# 1955 PITTWATER ROAD, BAYVIEW

S4.55 AMENDED PLANS

DRAWING LIST

Drawing Title  
North Elevation

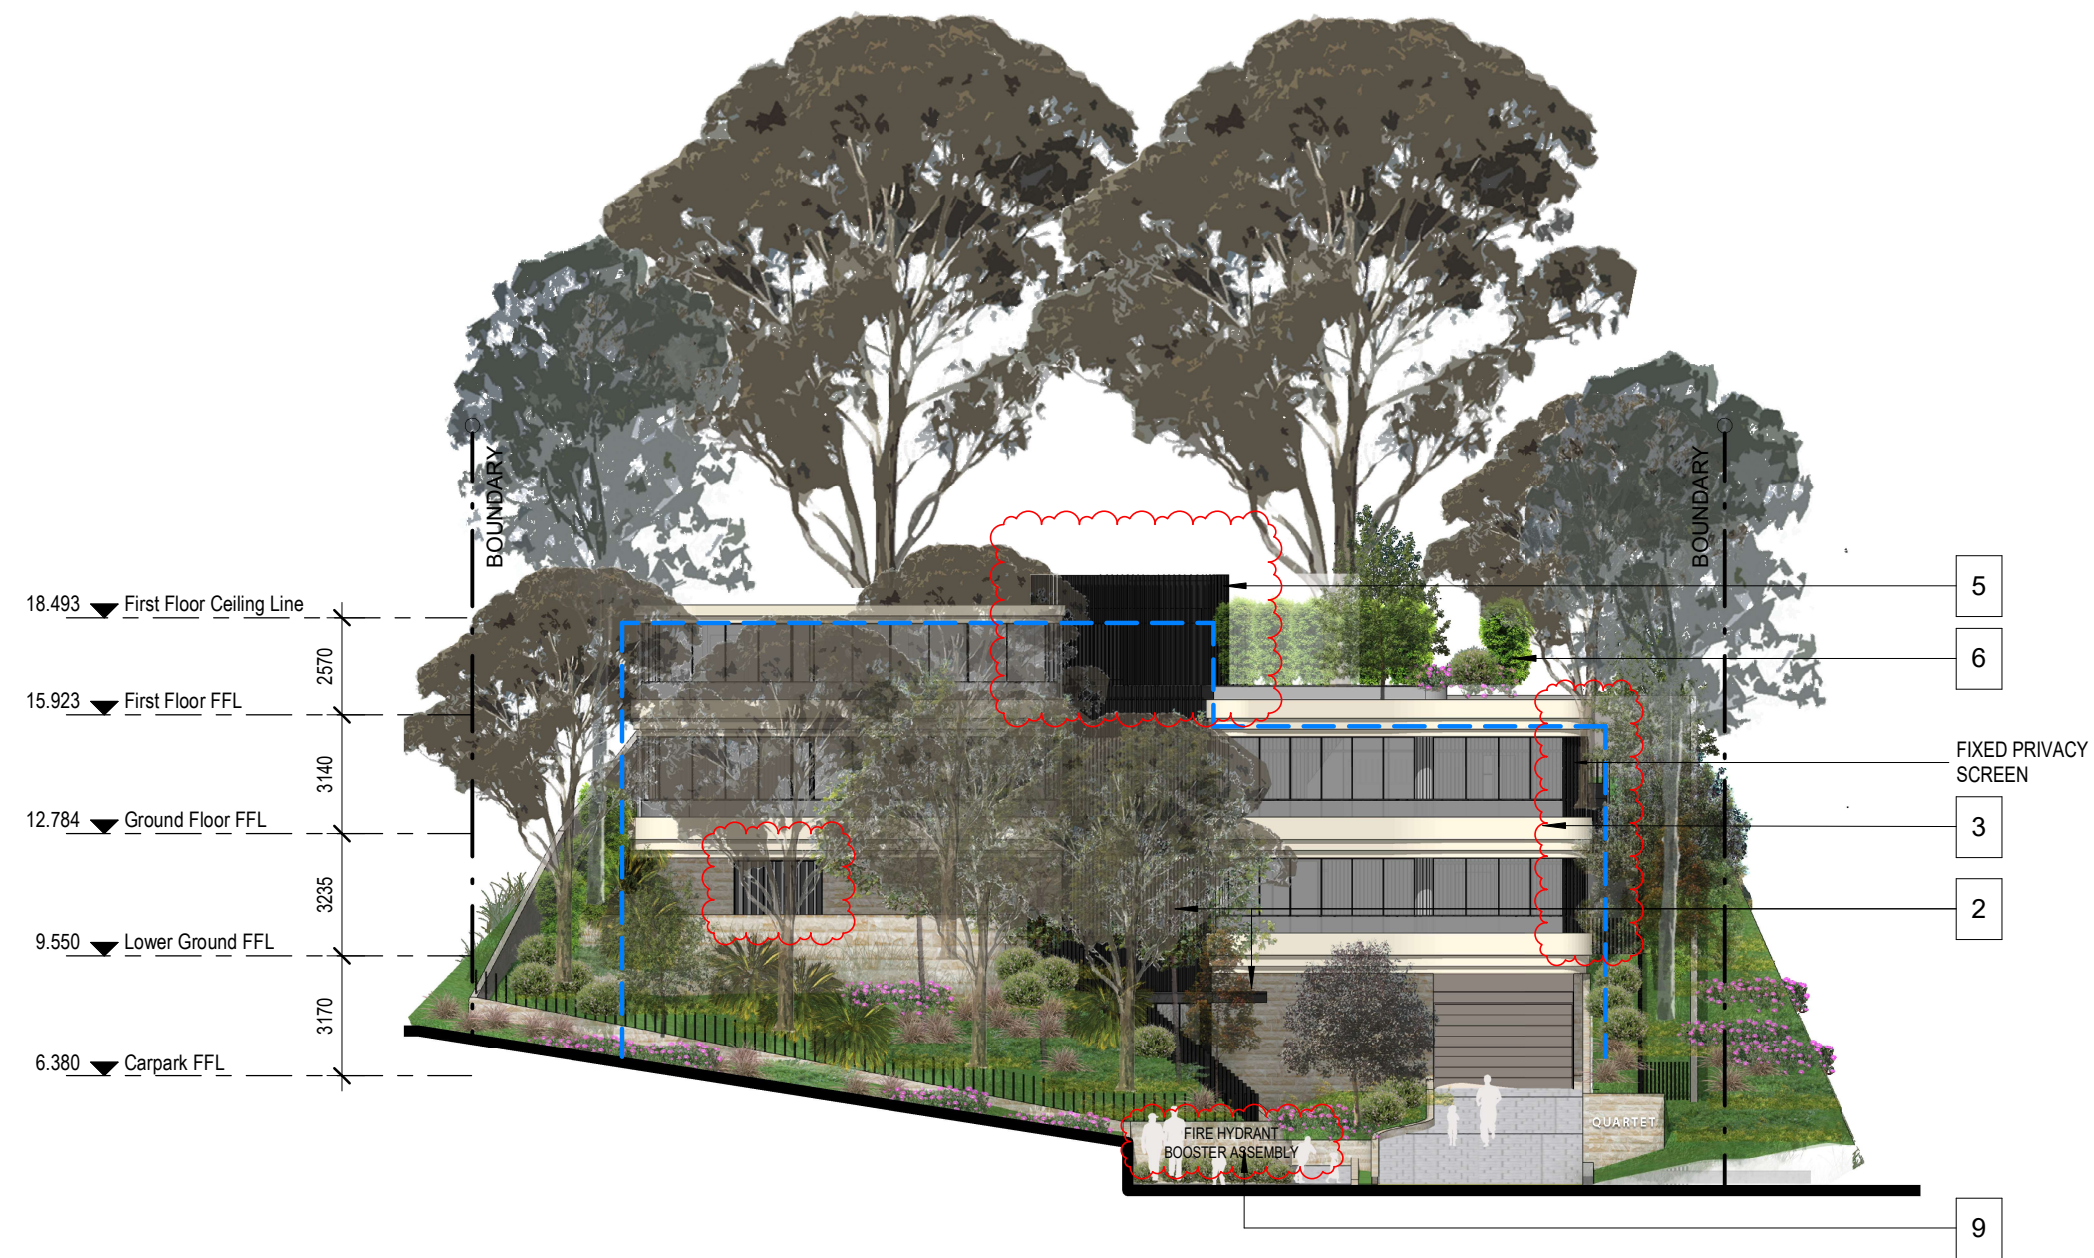
- 1. Entry Pedestrian Ramp** - Increased pedestrian ramp width to 1600mm for accessibility
- 2. Building Entry** - New awning and vertical louvre screen to increase sense of entry.

- 3. Balcony Articulation** - New curved balconies for improved aesthetics. Increase in outdoor private open space area and solar access for improved amenity

- 9. FRNSW Requirement** - to provide hardstand & fire hydrant booster assembly , requiring removal of tree T3 (Refer to Arborist Report).

Fire Hydrant Booster Assembly  
(to future supplier details)

Drawing Title  
West Elevation

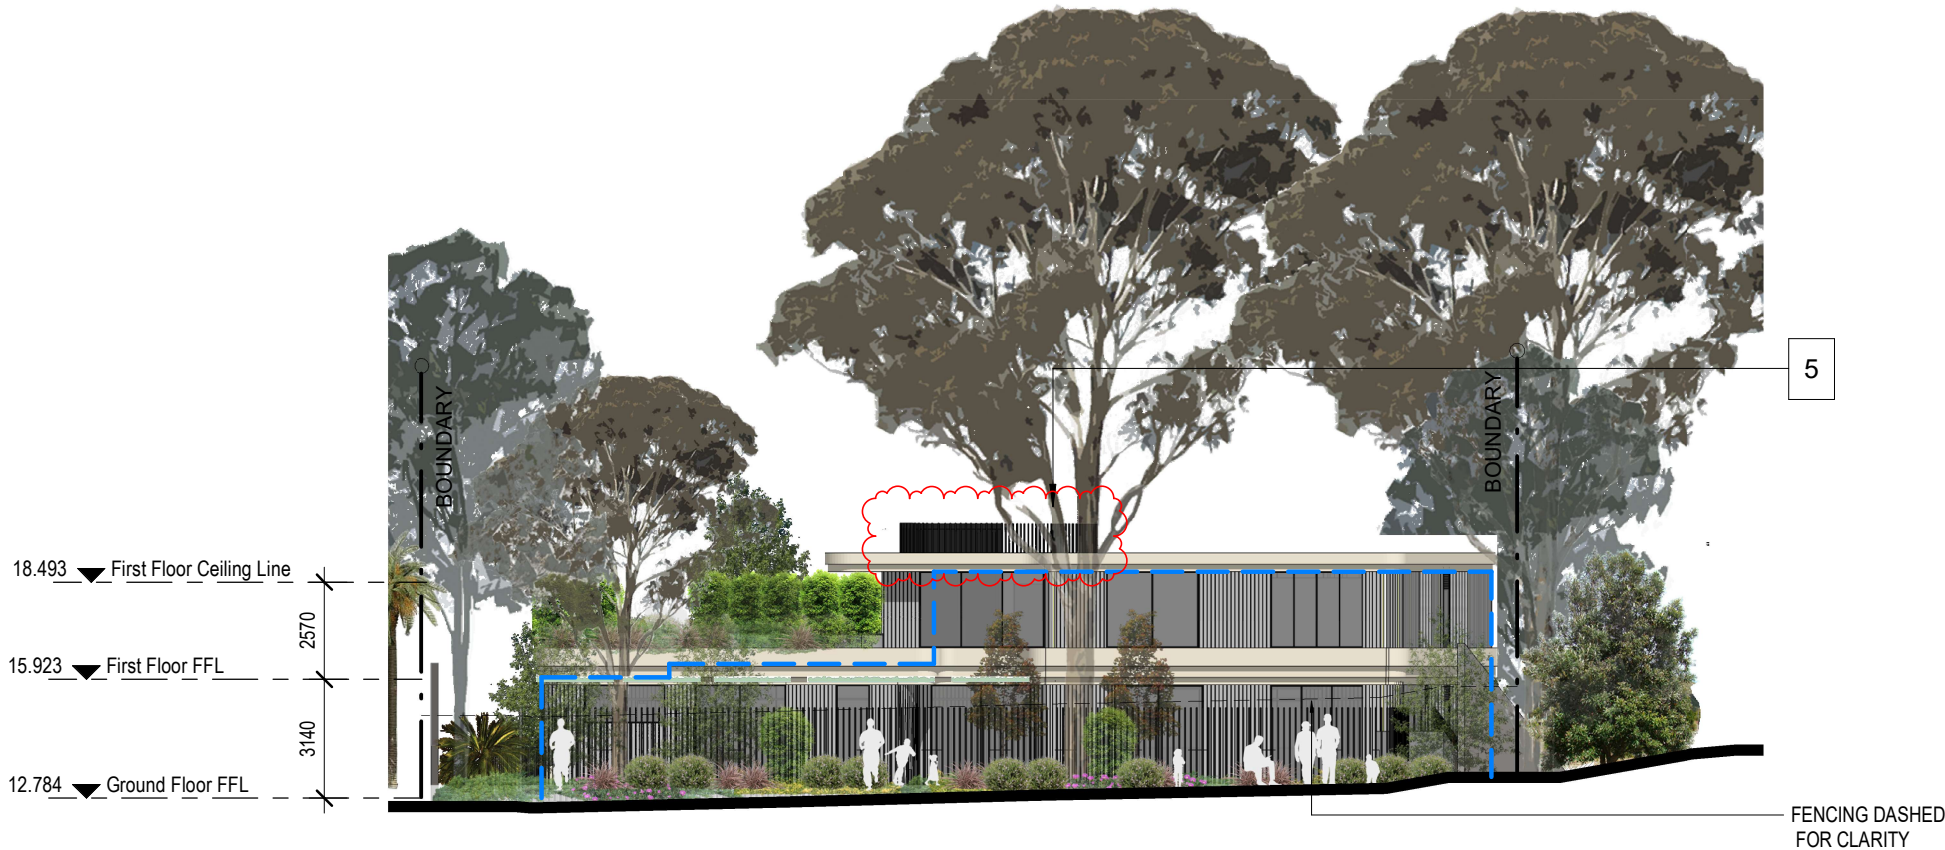
- 12. Unit layouts** - Internal reconfiguration and increase in unit size for improved amenity.
- 13. Elevations** - Removal of wall break in east elevation of Units 3 and 4. Revised façade and window treatments associated with plan amendments

- 14. Boundary Fence** - 1.8m high painted capped and lapped fencing in Dulux 'Winter Fog'
- 15. Vertical Screening** - Continuation of vertical screening over lift shaft to accentuate recess between the two modulated built forms

Drawing Title  
**East Elevation**

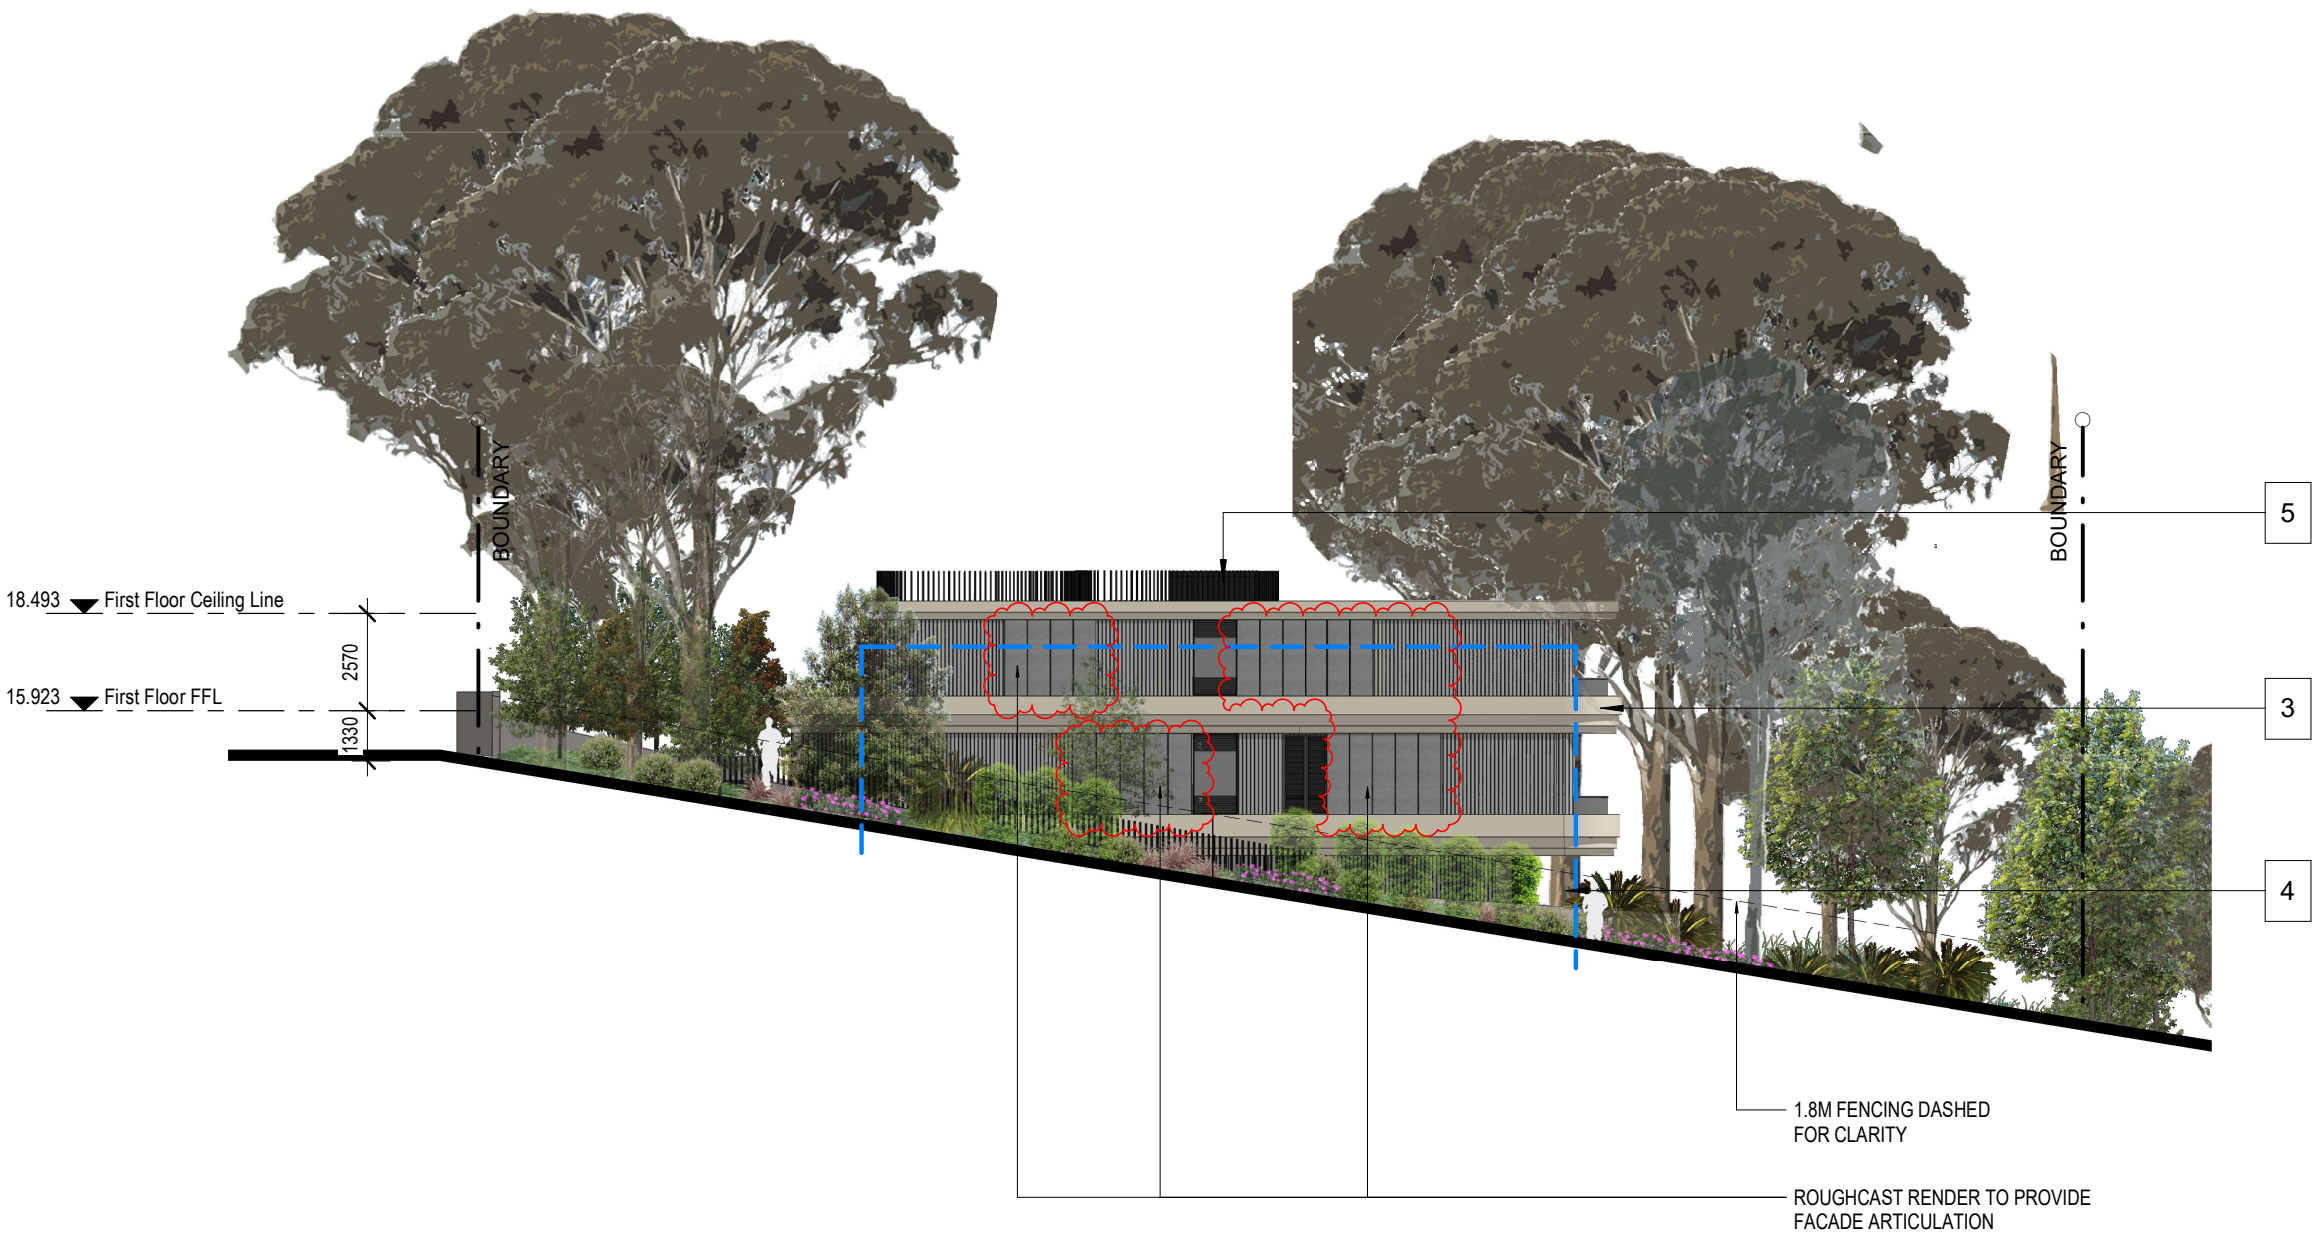
3. **Balcony Articulation** - New curved balconies for improved aesthetics. Increase in outdoor private open space area and solar access for improved amenity

4. **Fencing** - New fencing to provide safety and security
5. **Roof** - New rooftop plant enclosure to comply with services requirements
6. **First Floor Roof Deck/ Landscaping** - Change in configuration of First Floor roof deck to integrate with overall building aesthetics. New landscape buffer around perimeter of First Floor roof deck for improved privacy and softening of built form
